# CONSTRUCTION DOCUMENTS MAYBERRY, COLORADO - FILING NO. 4

BEING A REPLAT OF TRACT A, MAYBERRY, COLORADO SPRINGS FILING NO. 3  
LYING THE NORTHEAST QUARTER OF SECTION 14, TOWNSHIP 14 SOUTH, RANGE 63 WEST OF THE 6TH PRINCIPAL MERIDIAN  
COUNTY OF EL PASO (UNINCORPORATED), STATE OF COLORADO

PCD FILE NO. SF2317

**LOT 3 STUB PROFILE VIEW**  
HORIZONTAL SCALE: 1"=20'  
VERTICAL SCALE: 1"=4'

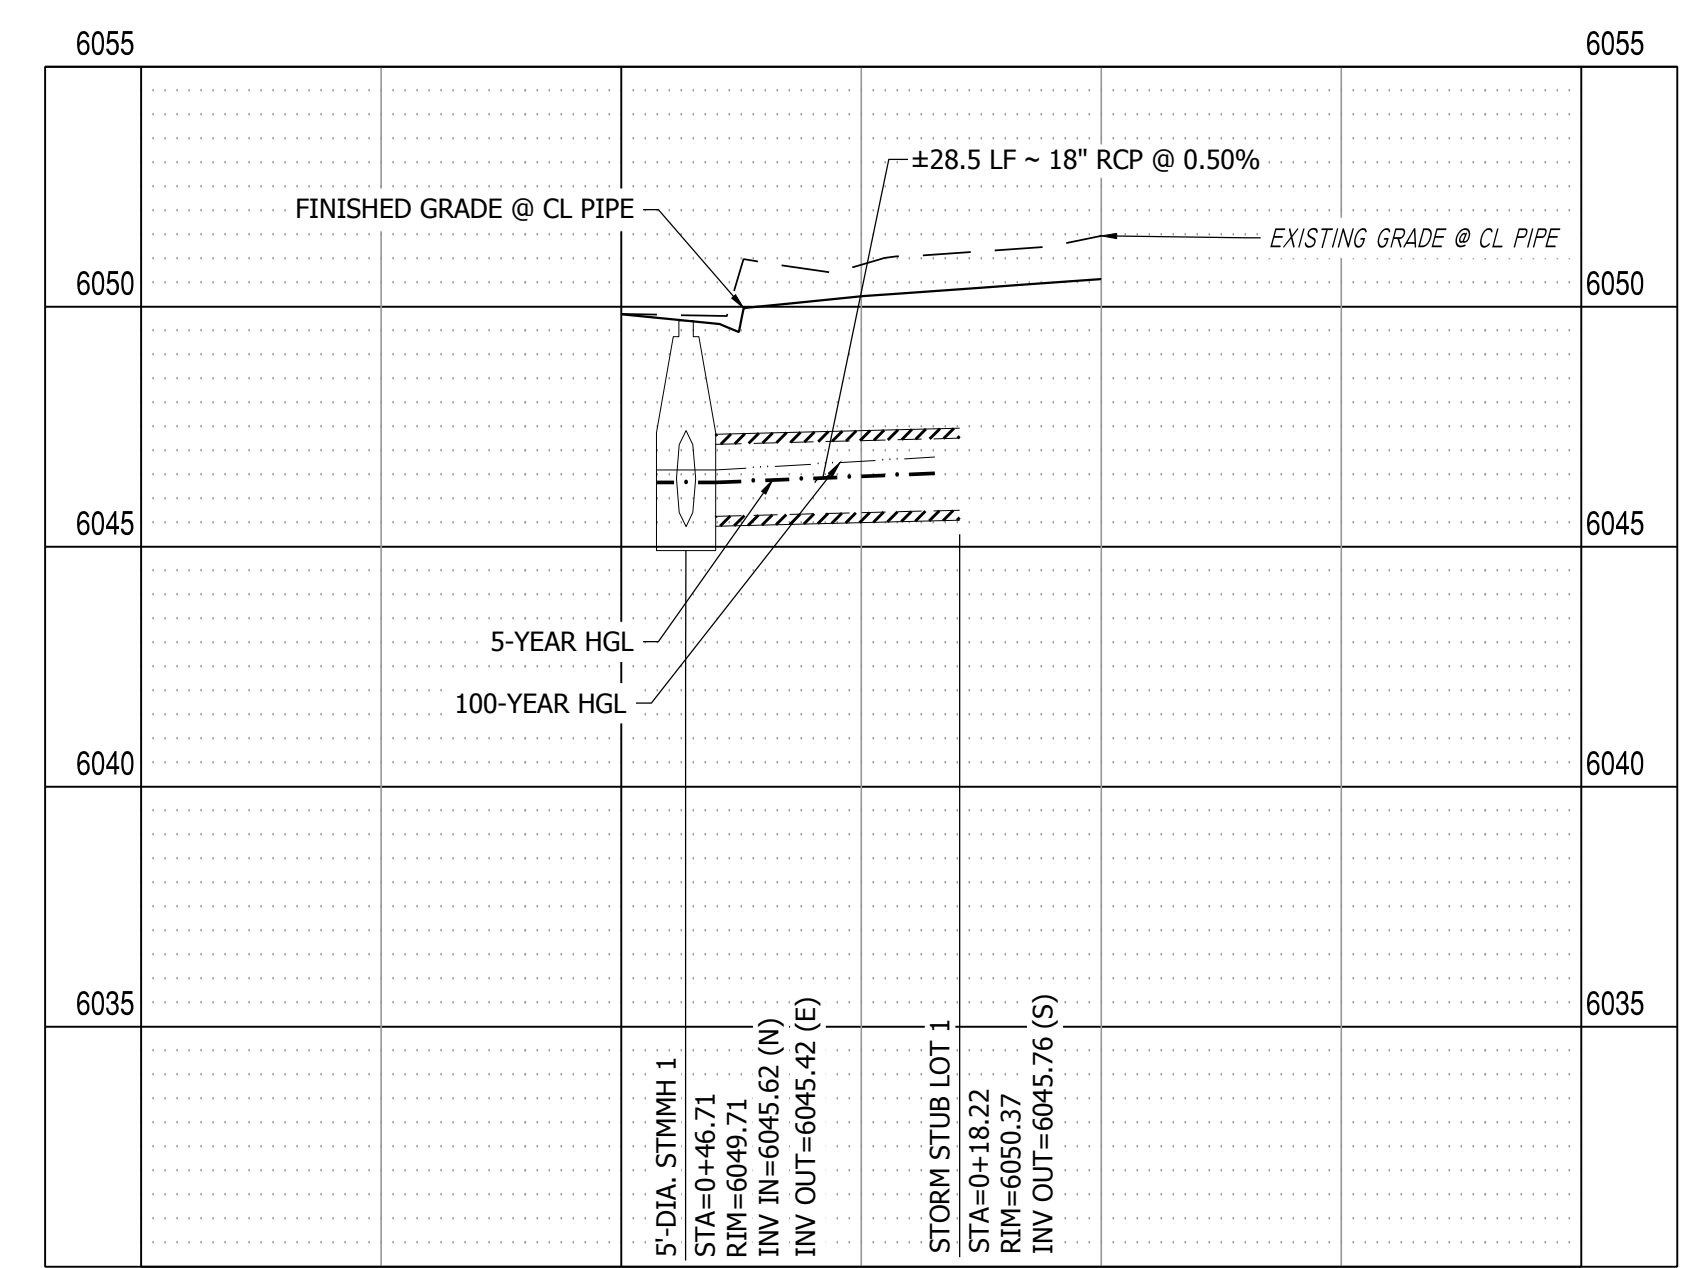
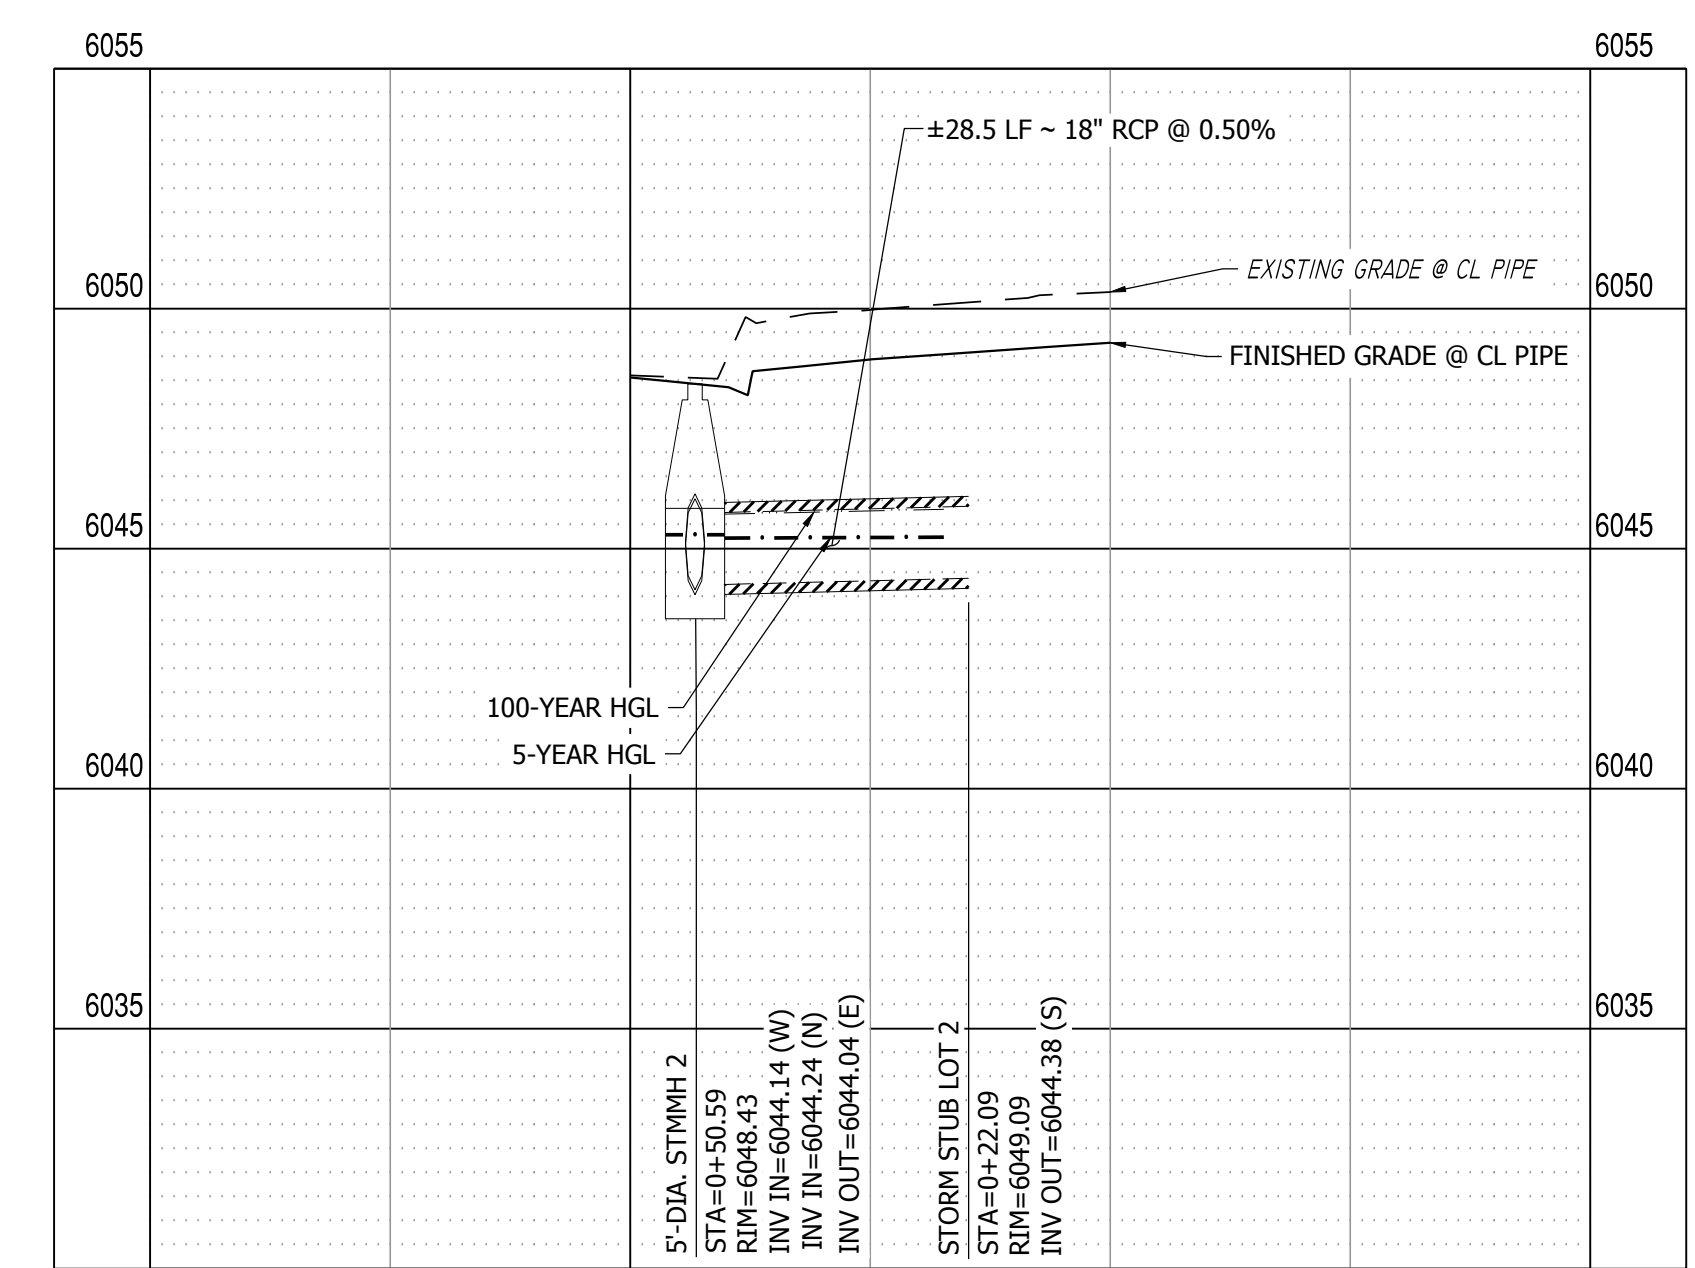
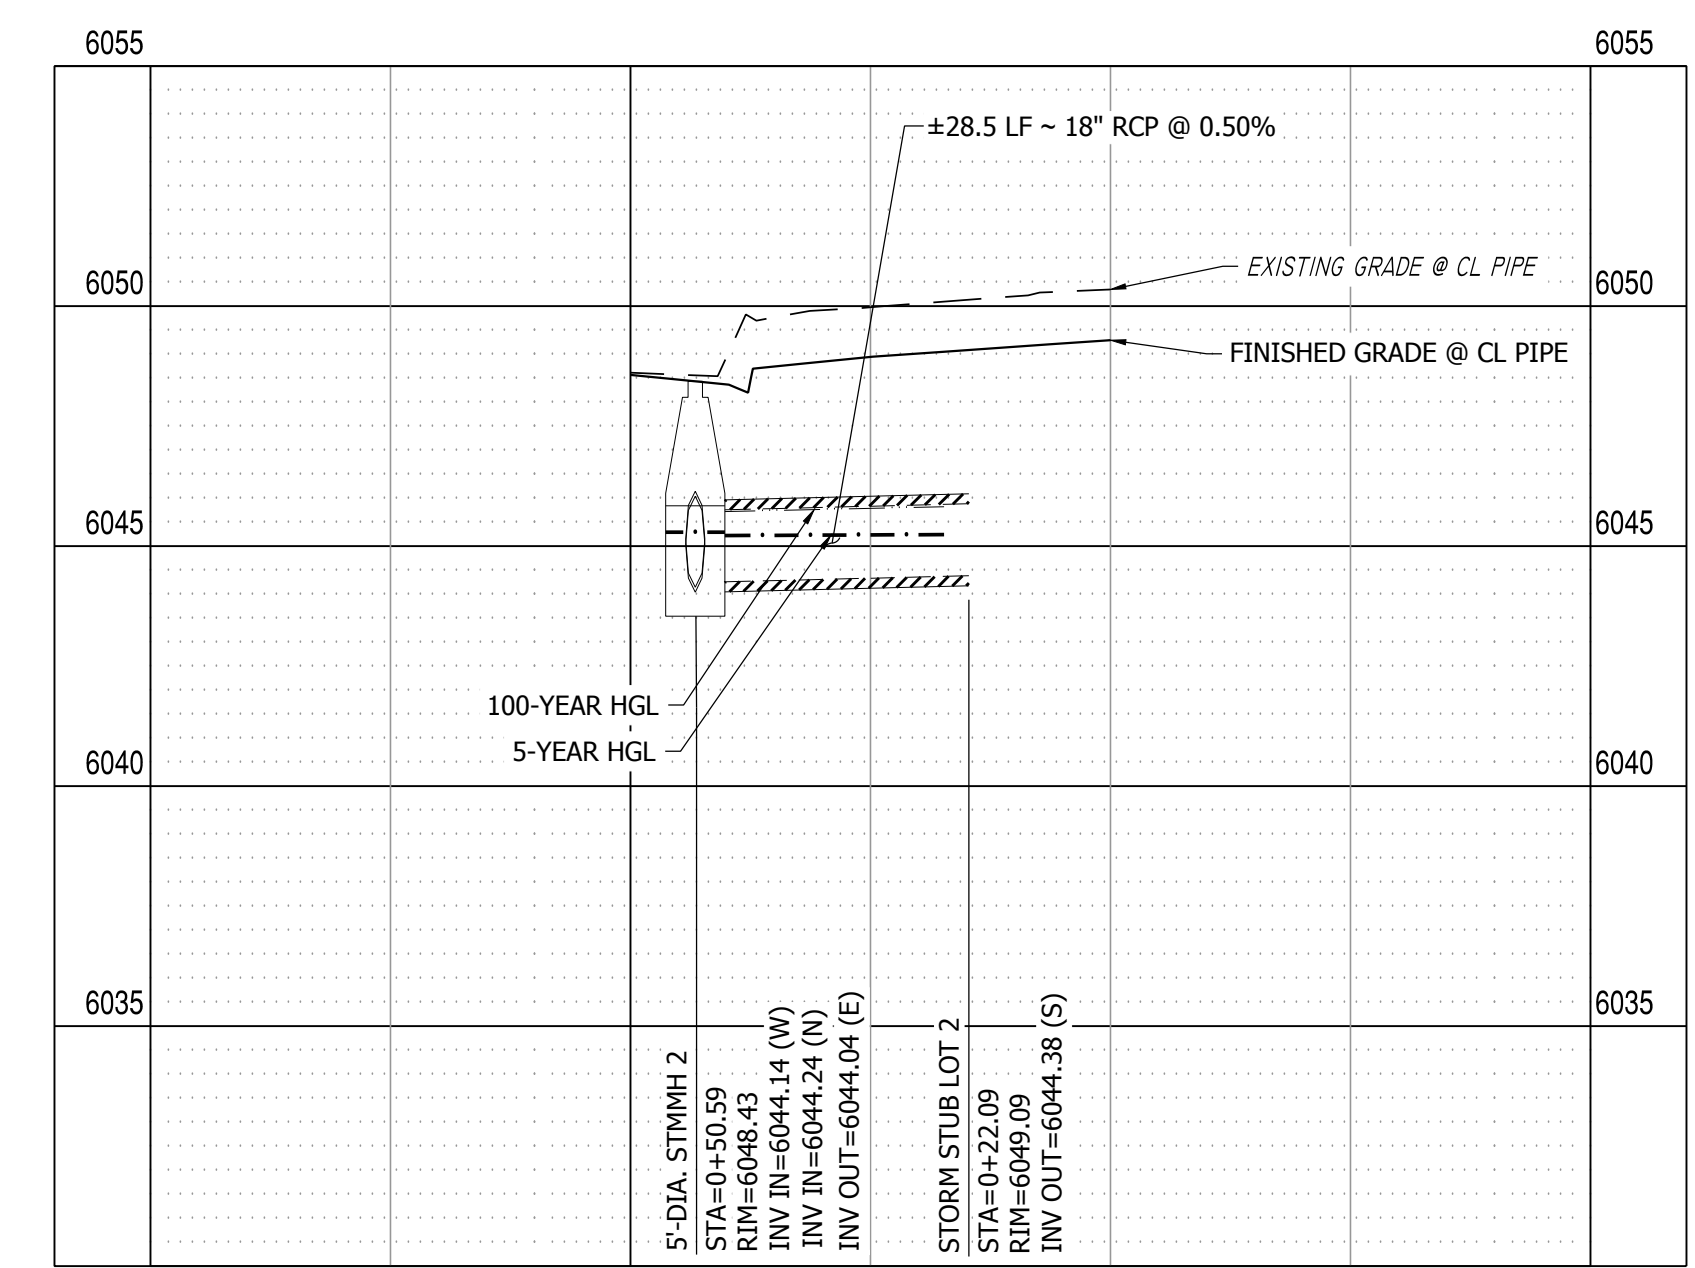
Provide lot 3 profile  
as this appears to be  
a repeat of lot 2  
profile

NO. C5.3

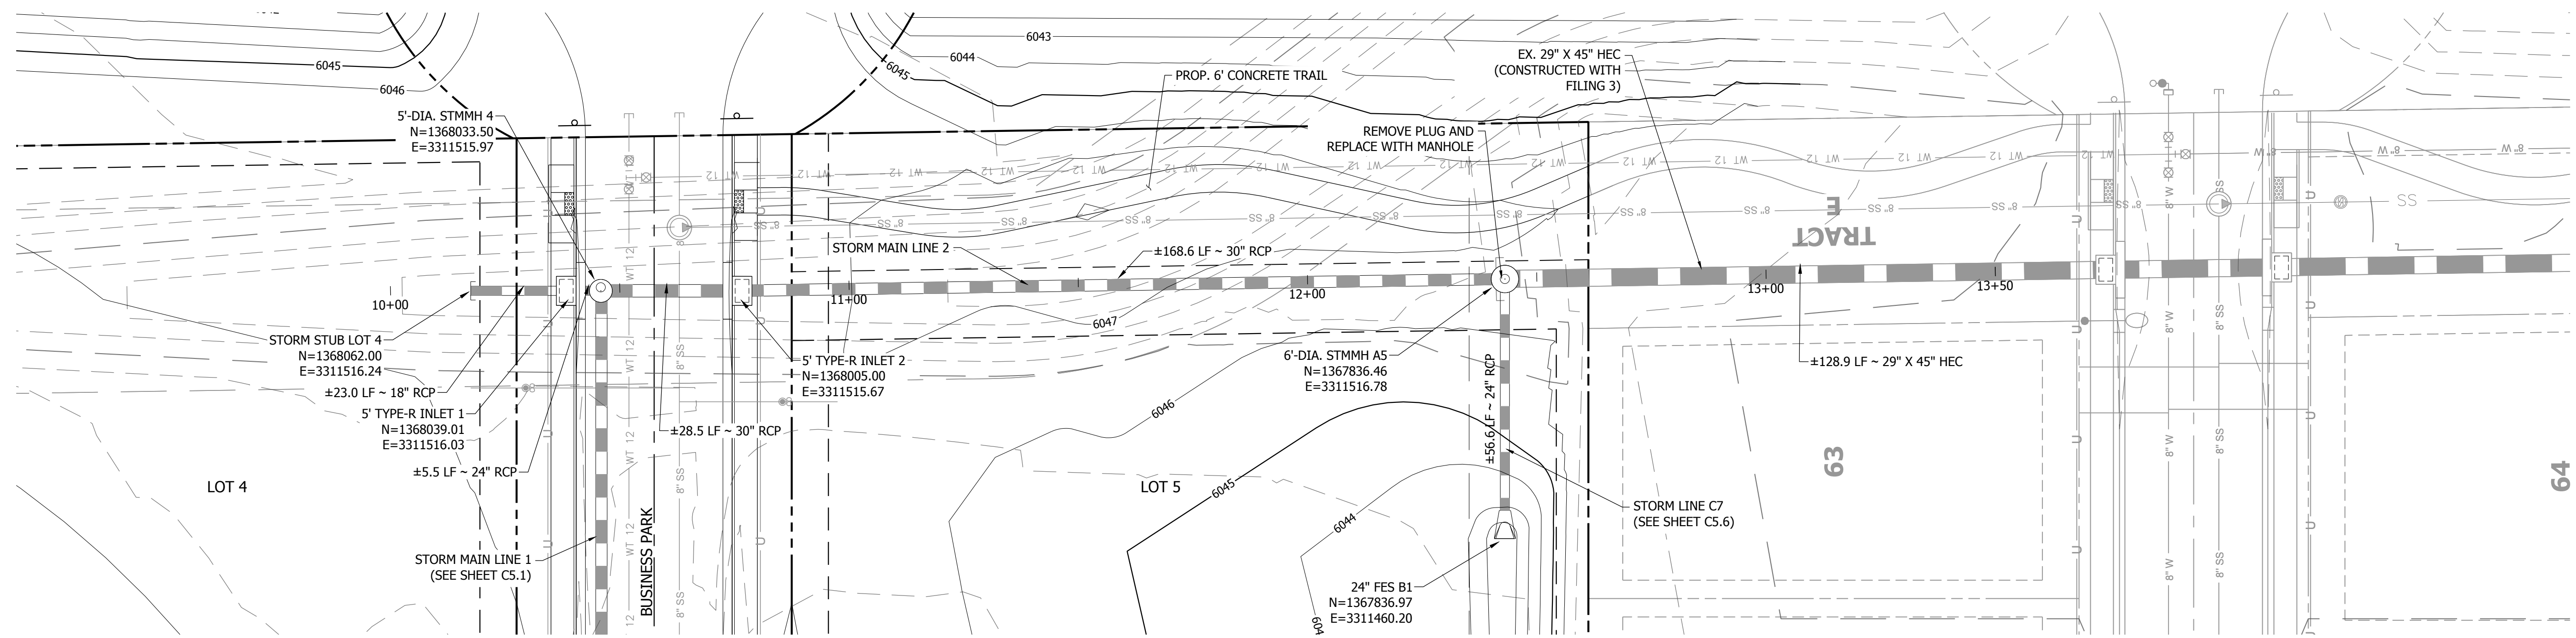
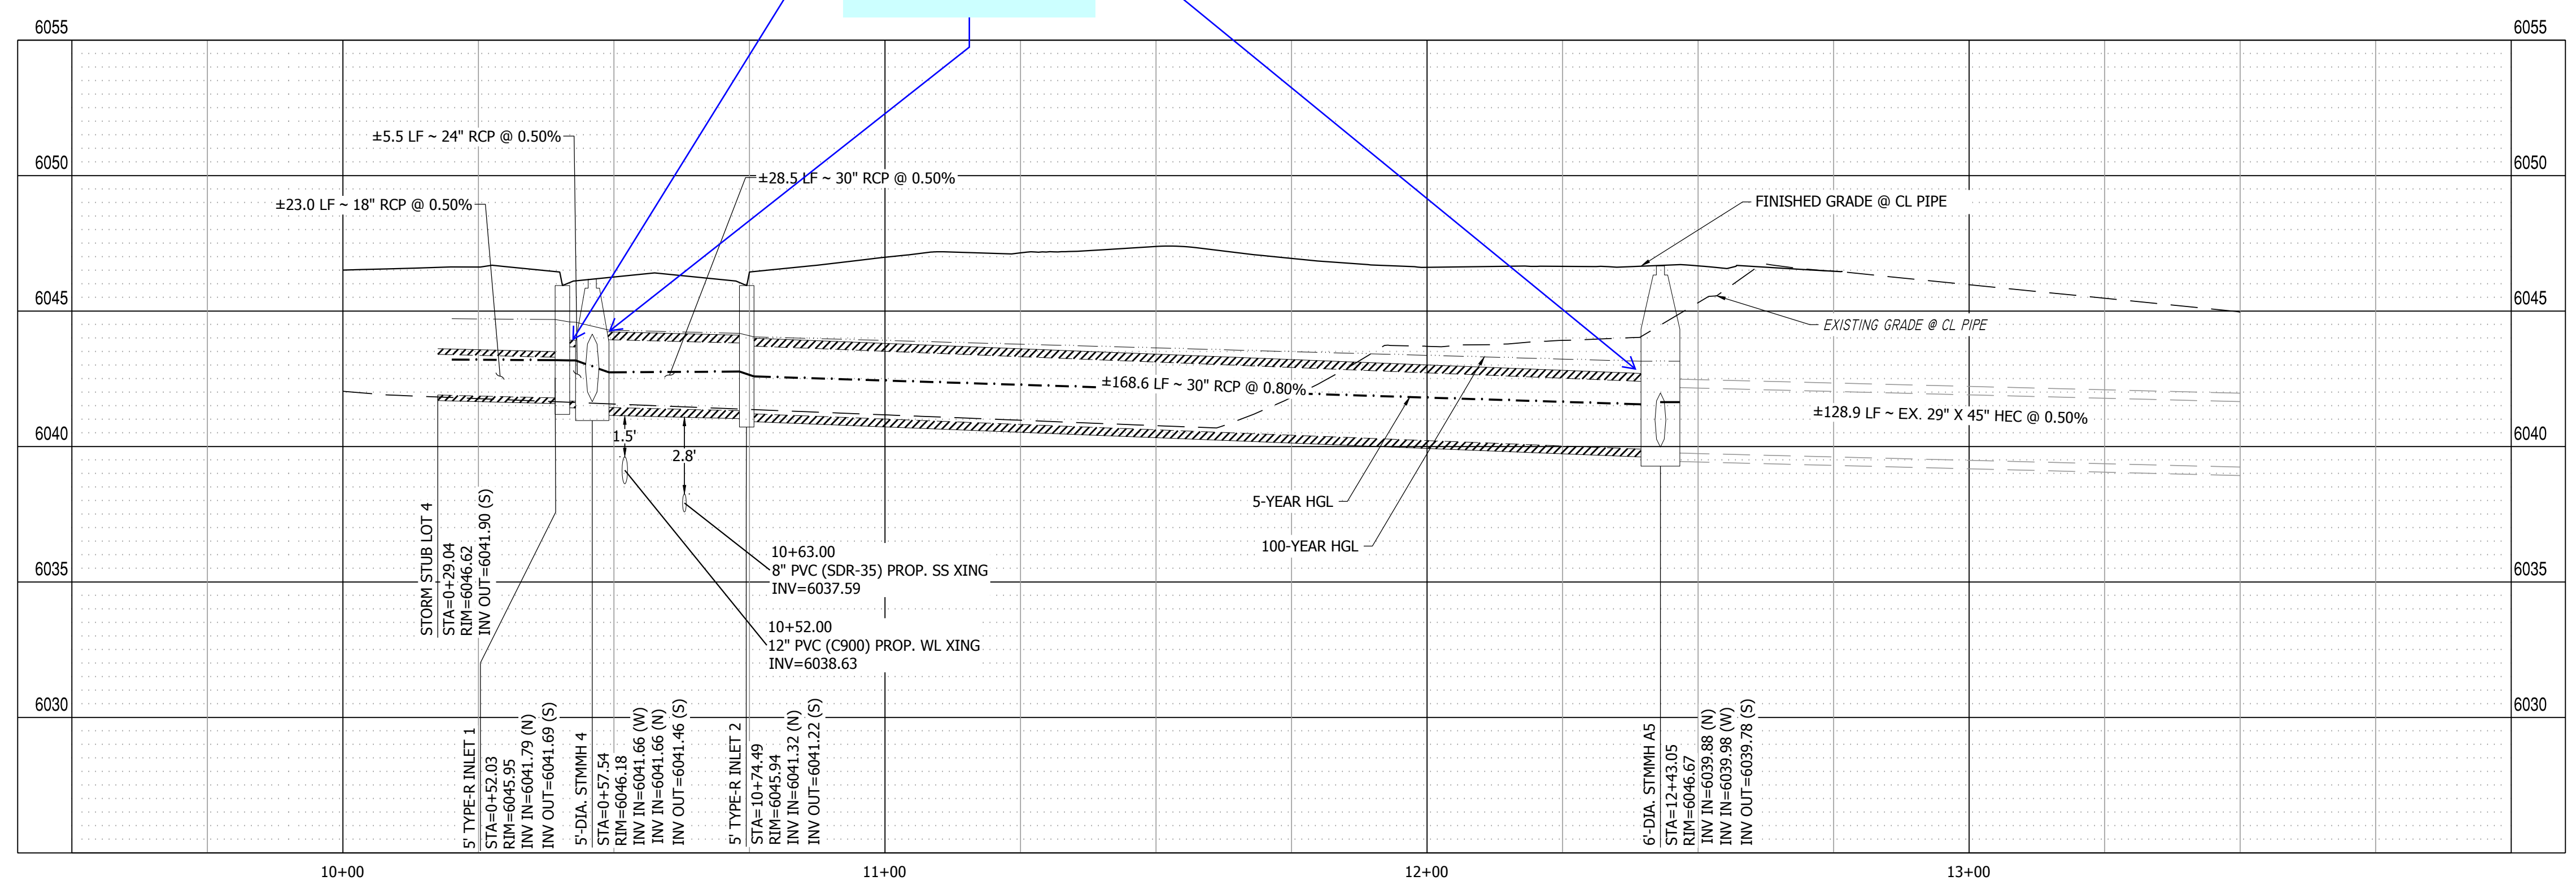
per ECM 3.3.1.J.2 where the conduit size increases the inside top slope of the conduits shall be continuous in elevation. Please revise.
